MAYOR AND COUNCIL AGENDA

ACTION: Discussion and Instruction on Preliminary Development Plan application PDP2004-00007: To allow for a mixed-use development of office, residential and retail uses at the corner of Choke Cherry Road and Shady Grove Road (Upper Rock District); The JBG Companies, applicants.

**SUMMARY OF TESTIMONY FOR PUBLIC HEARING
HELD DECEMBER 6, 2004
PDP2004-00007
UPPER ROCK DISTRICT**

**CITY OF ROCKVILLE PLANNING DIVISION
STAFF REPORT**

View of Landscaped Art Wall from I-270 ramp

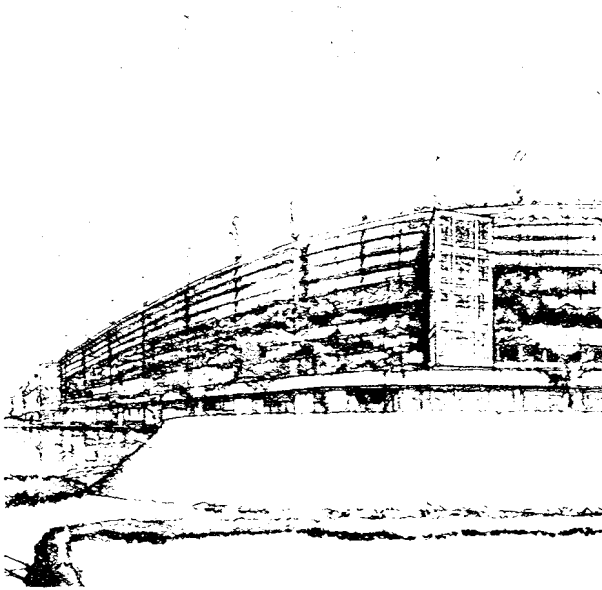
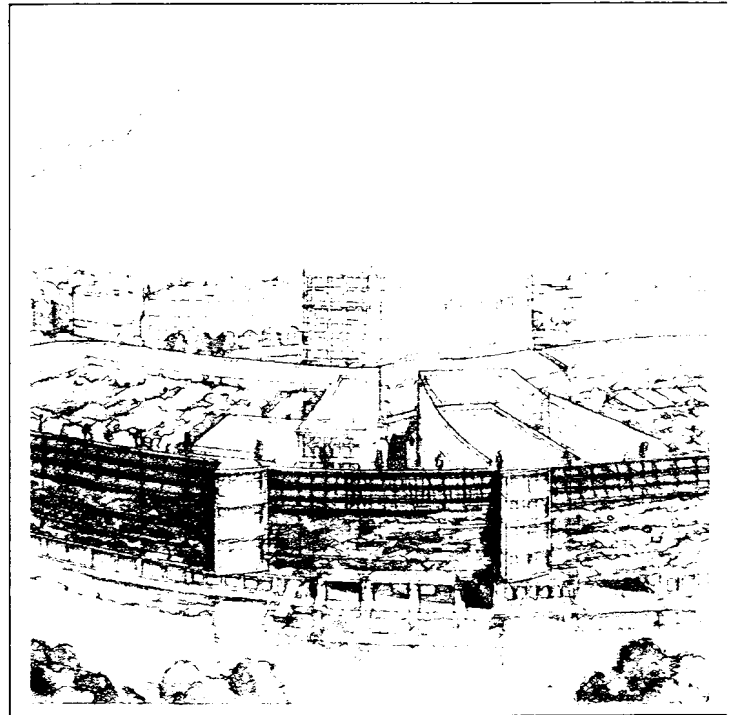
In response to the request for additional information regarding the landscaped wall (formerly known as the "art wall"), we offer the following:

Details of the design of the wall, including the construction materials, art content, maintenance, etc. will be addressed at the Use Permit stage.
